Access Compliance Report

Public Rights-of-Way (Curb Ramps)

Intersection ID: 43666	Main Street: CORSICA_FOREST_DR	Cross Street: ASHETON_CREEK_DR	Location: NW
ADA ID: B10832B6E5A8	Ramp Type: PerpDiag	Initial Pass/Fail: Fail	Overall Compliance: No
Severity Score: 1.25			
Codes/Mitigation Info/Possible Solution		Field Measurements/Component Compliance

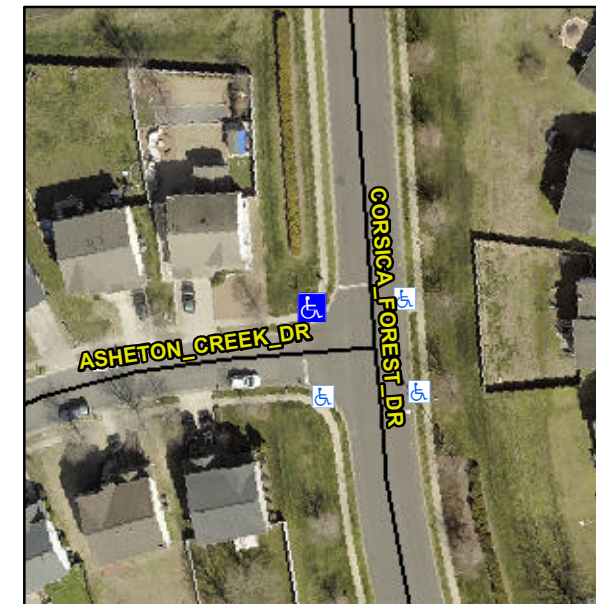
R304.5.3

Compliance	Description	Data	Compliance	Description	Data
N/A	Ramp Length (in)	48.0	Yes	Ramp Slope (%)	5.3
Yes	Ramp Width (in)	48.0	No	Ramp XSlope (%)	2.3
N/A	Flare Type LT	N/A	N/A	Flare Type RT	N/A
N/A	Flare Slope LT (%)	N/A	N/A	Flare Slope RT (%)	N/A
N/A	Flare Traversable LT?	N/A	N/A	Flare Traversable RT?	N/A
N/A	Landing Length (in)	N/A	N/A	DWS Provided?	N/A
N/A	Landing Width (in)	N/A	N/A	DWS Contrast?	N/A
N/A	Landing Slope (%)	N/A	N/A	DWS Length (in)	N/A
N/A	Landing X Slope (%)	N/A	N/A	DWS Full Width?	N/A
N/A	Landing Curb? (Y/N)	N/A	N/A	DWS Offset (in)	N/A
N/A	Shared Landing?	N/A			
N/A	Gutter Ponding?	N/A	N/A	Gutter Slope (%)	N/A
N/A	Gutter Lip Ht (in)	N/A	N/A	Gutter X Slope (%)	N/A
N/A	Painted X Walk1?	No	N/A	Painted X Walk2?	No
	X Walk 1 Direction	To S		X Walk 2 Direction	To E
N/A	X Walk 1 Width (in)	N/A	N/A	X Walk 2 Width (in)	N/A
	X Walk 1 Slope (%)	0.7		X Walk 2 Slope (%)	1.2
	X Walk 1 X Slope (%)	0.8		X Walk 2 X Slope (%)	0.1

Remove & Replace Curb Ramp With Two New Directional Ramps or Equivalent.
